ADDENDUM

ADDENDUM NO.: 01
PROJECT NAME: Sheridan Elementary School Annex
PROJECT NO.: 05075
CONTRACT NO.: C1581
DATE OF ISSUE: September 1, 2017

NOTICE OF CHANGES, MODIFICATIONS, OR CLARIFICATIONS TO CONTRACT DOCUMENTS

TITLE:
ELEVATOR SECTION & ELEVATOR DETAILS

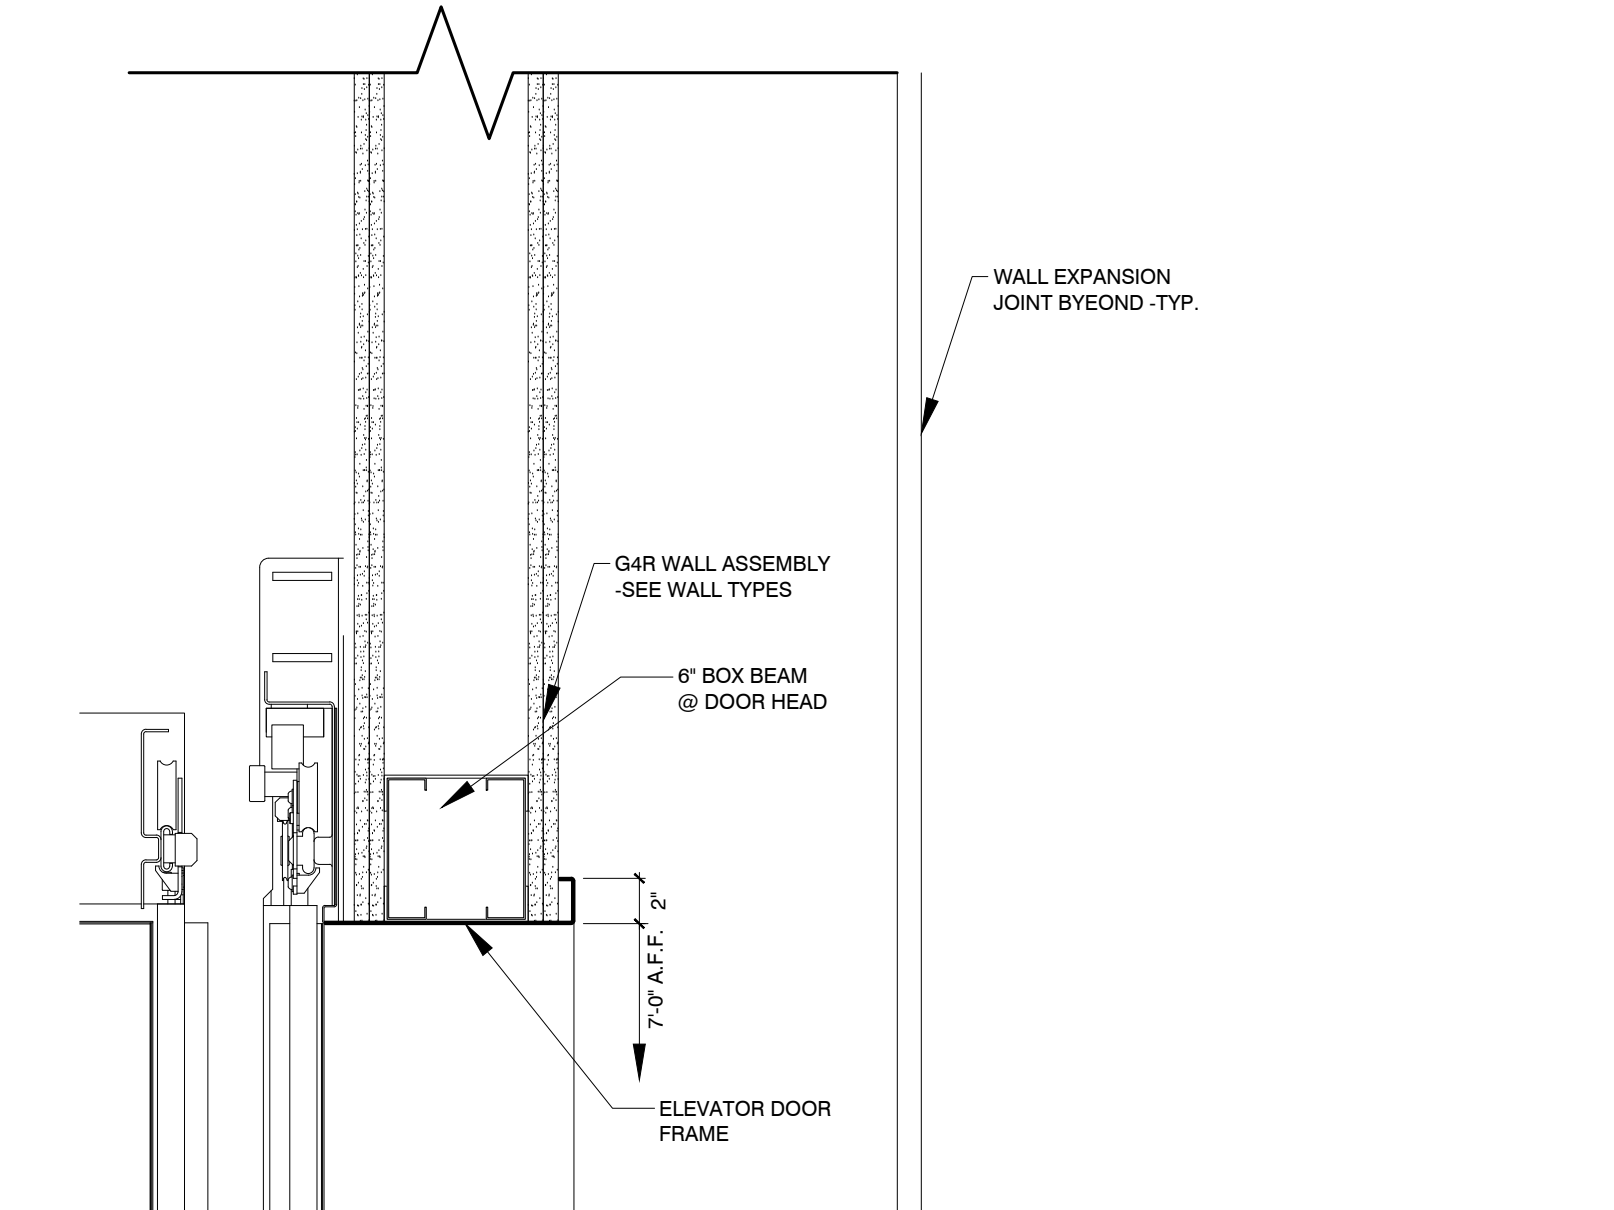
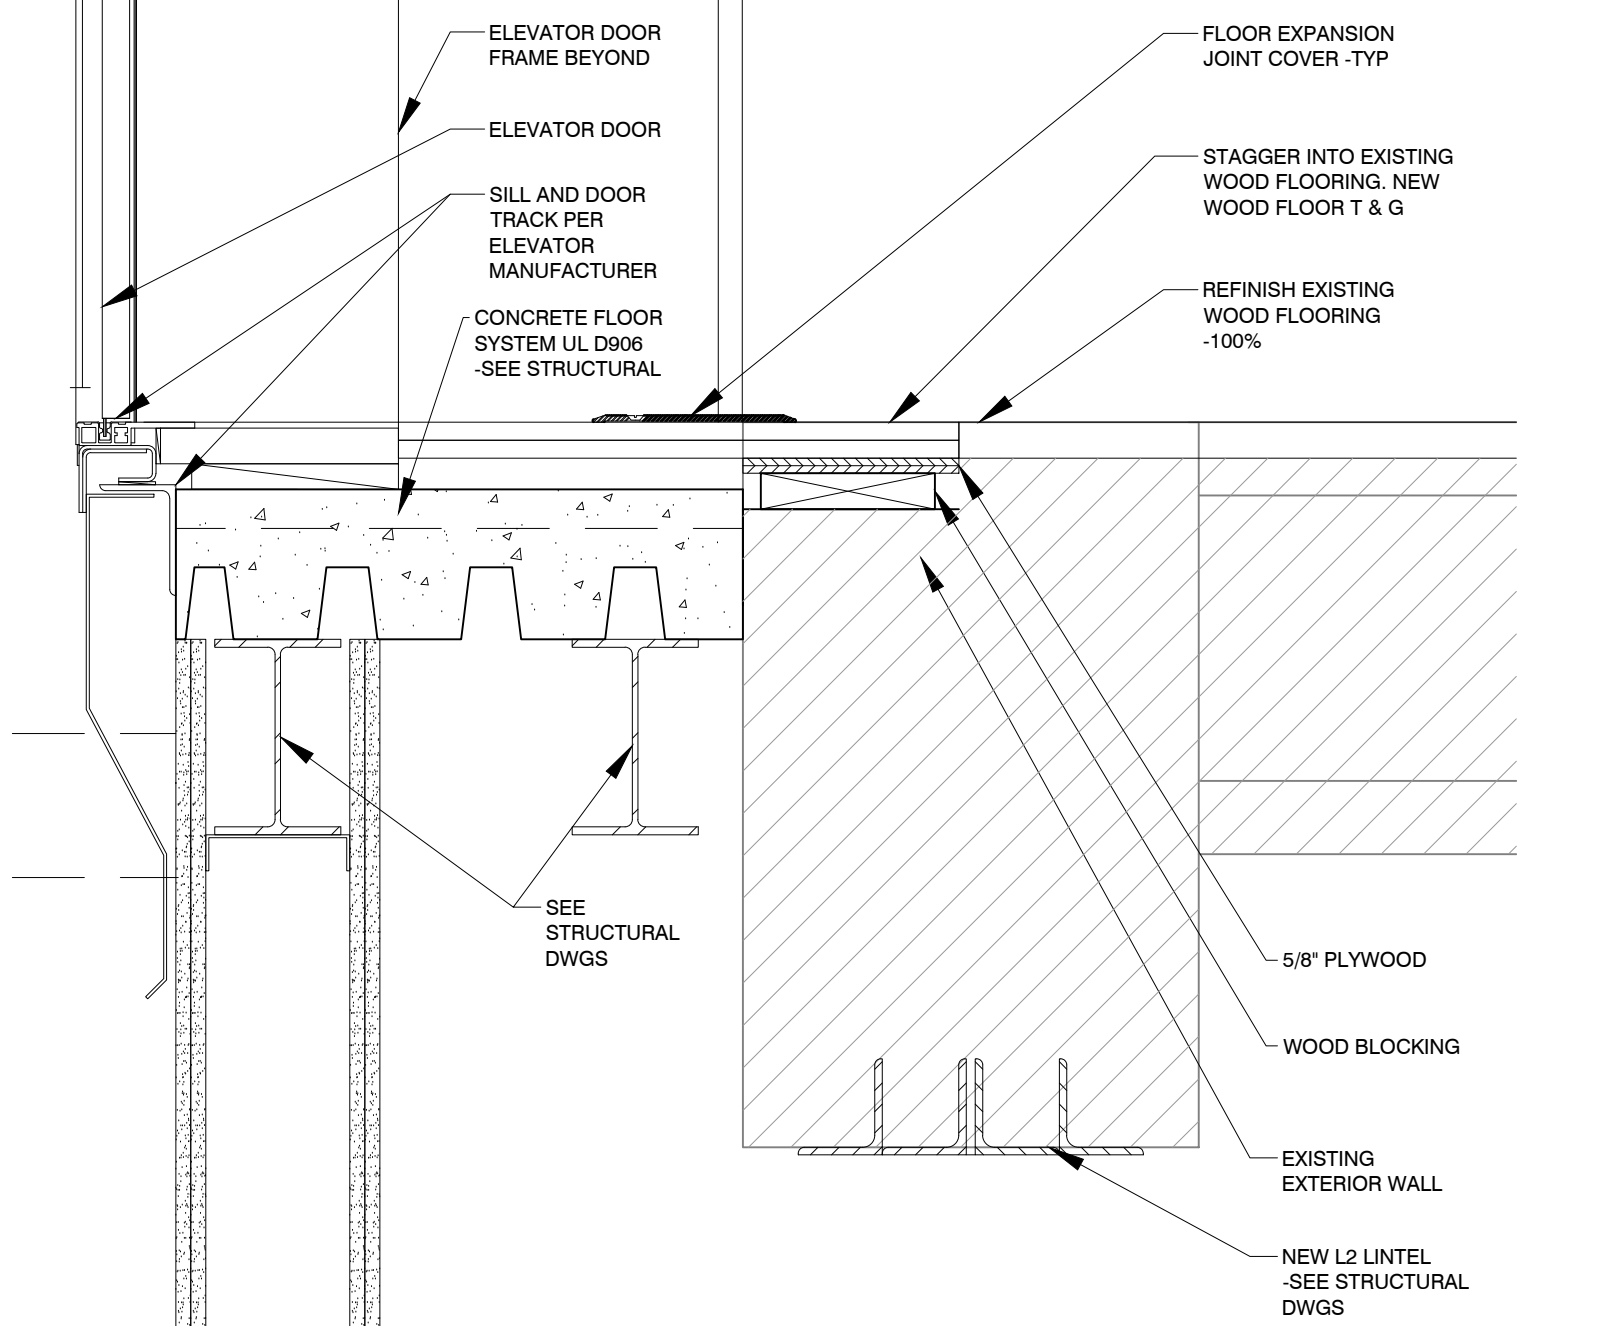
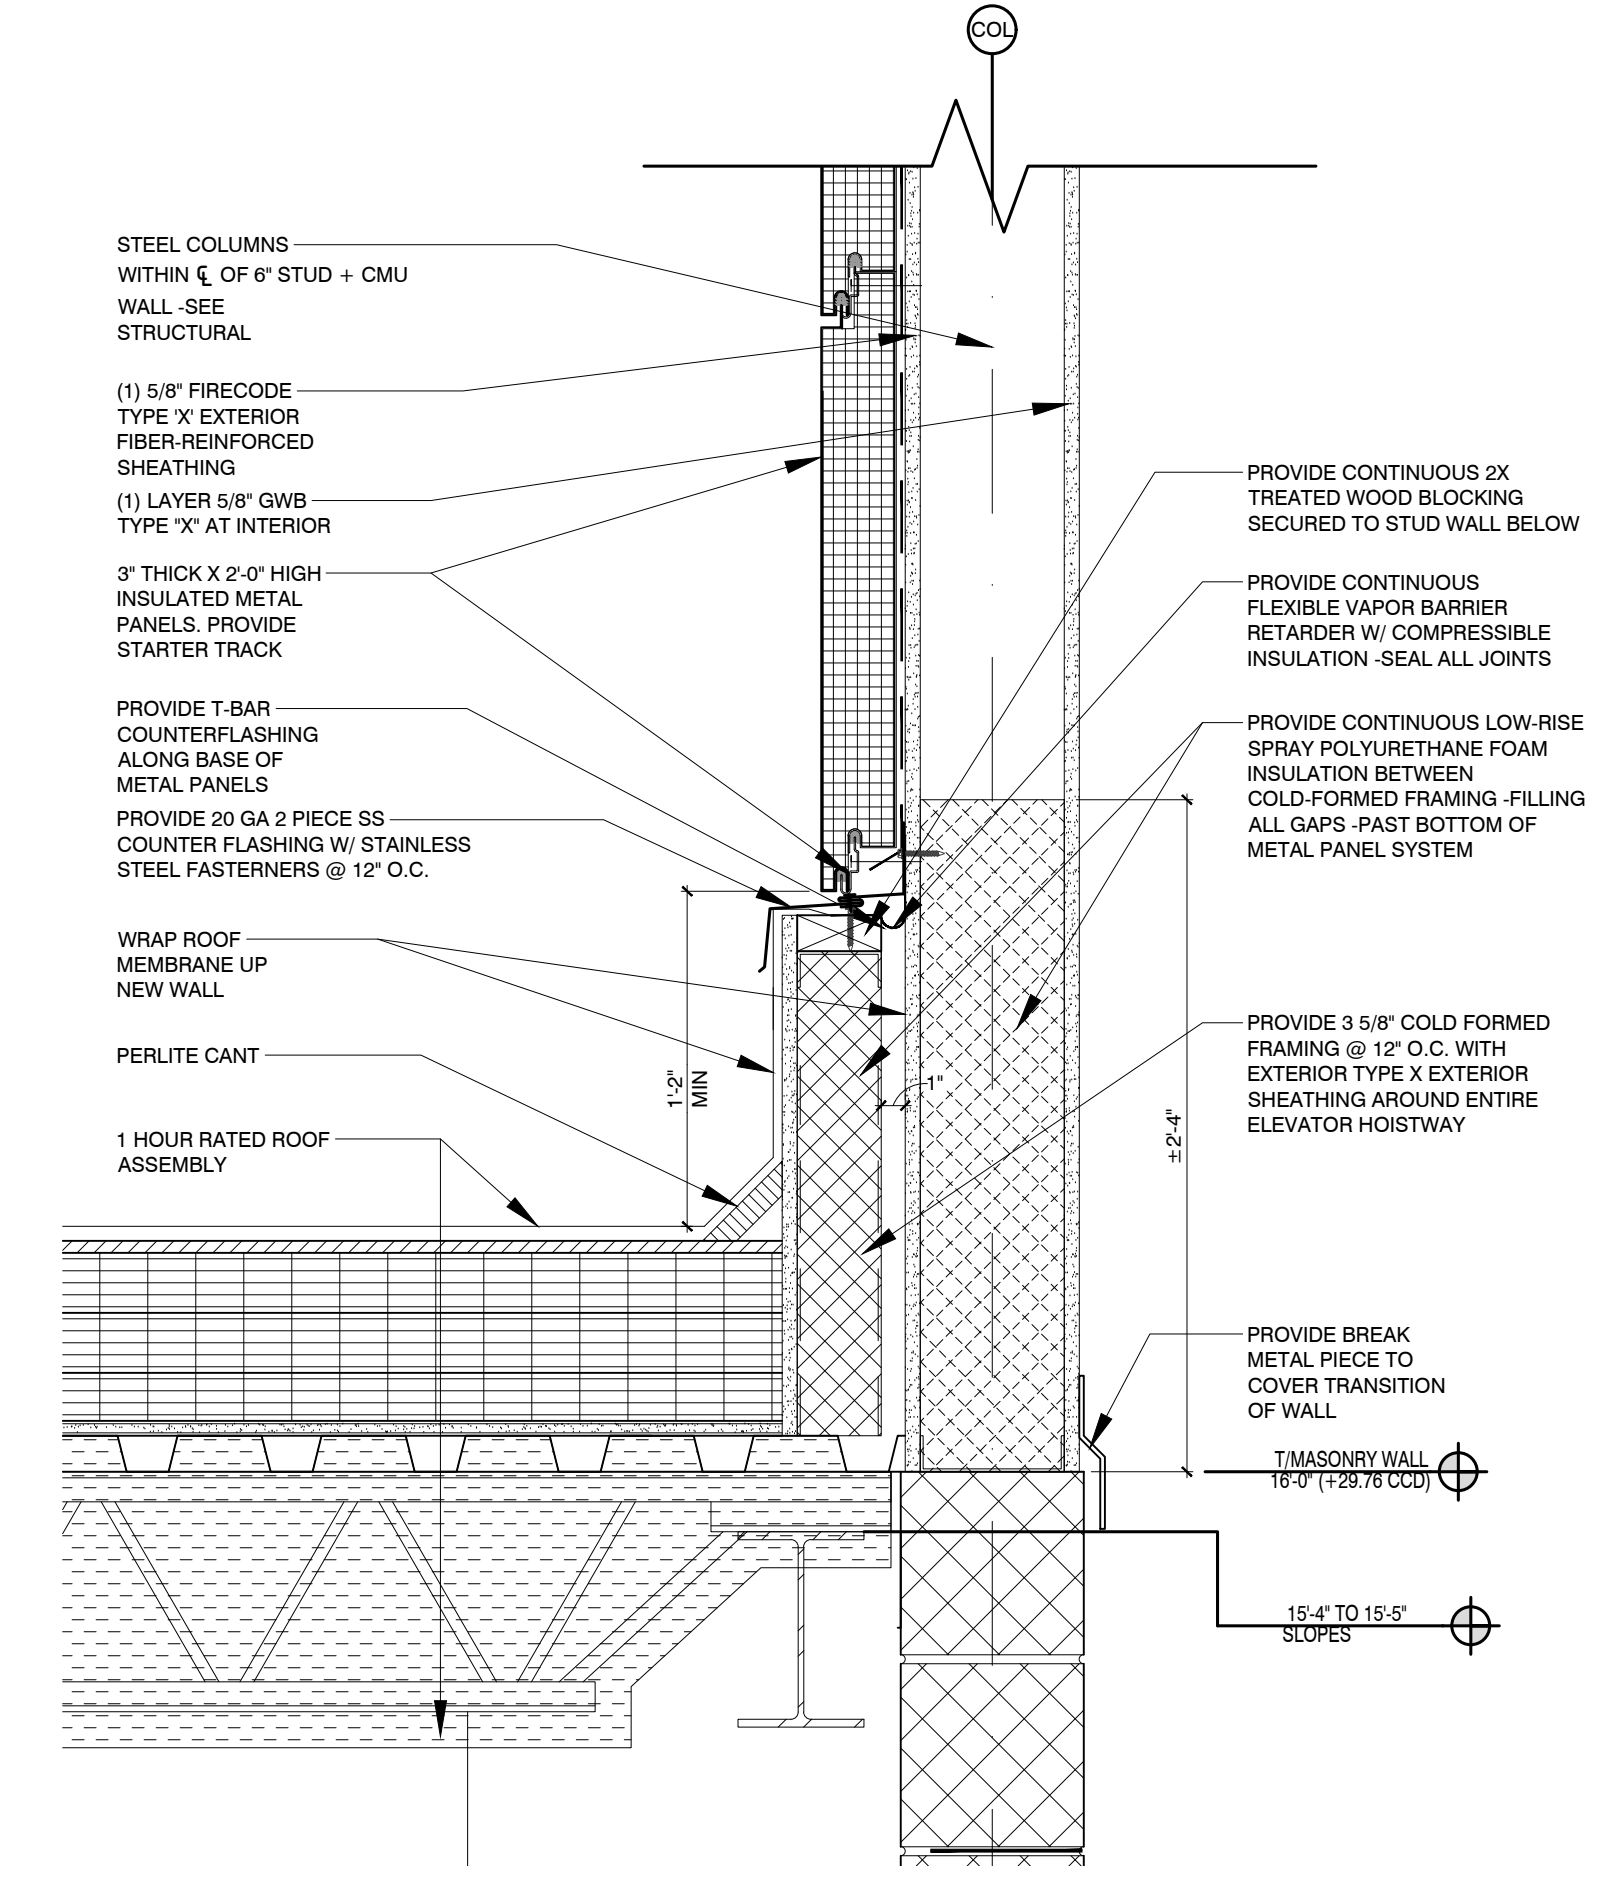
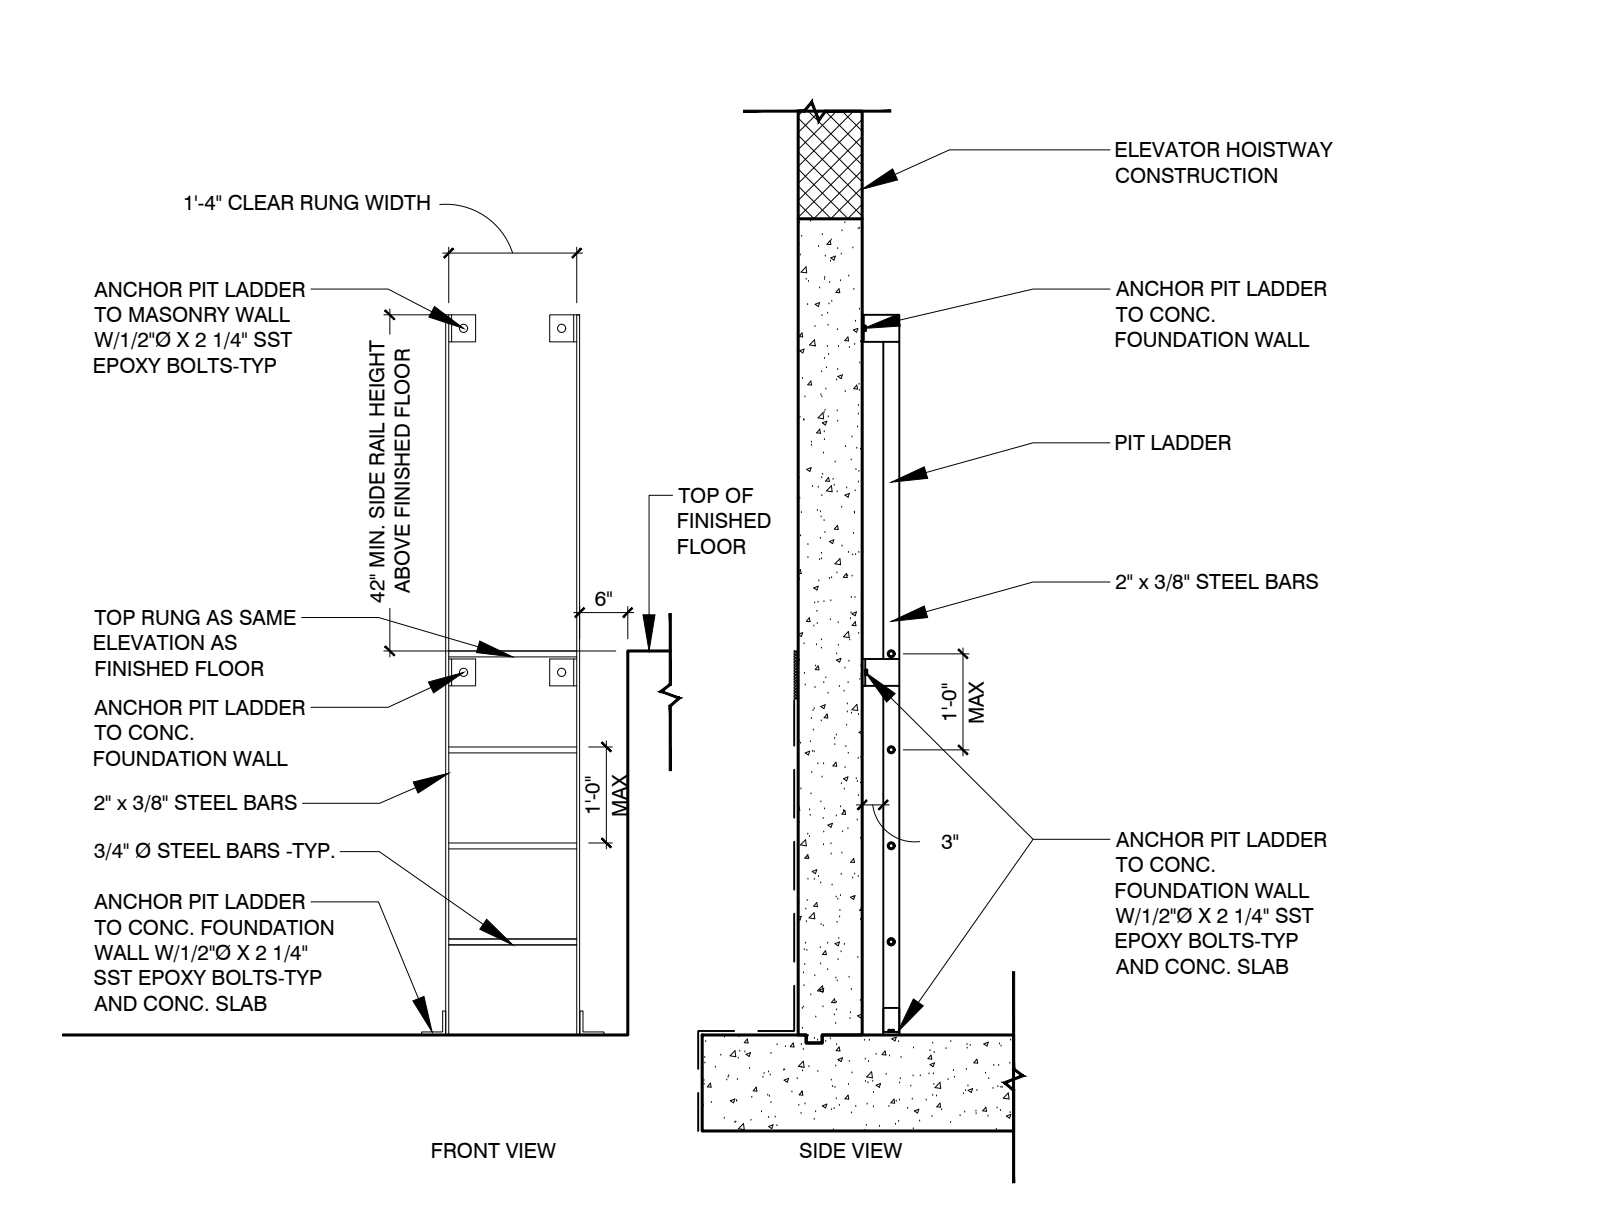
- Change 7. REVISED** – Drawing No. A32 – ELEVATOR SECTION & ELEVATOR DETAILS: Increased R value of insulated metal panels at elevator to R-20
- Change 8. REVISED** – Drawing No. A34 – WALL SECTIONS: Increased R value of insulated metal panels at elevator to R-20
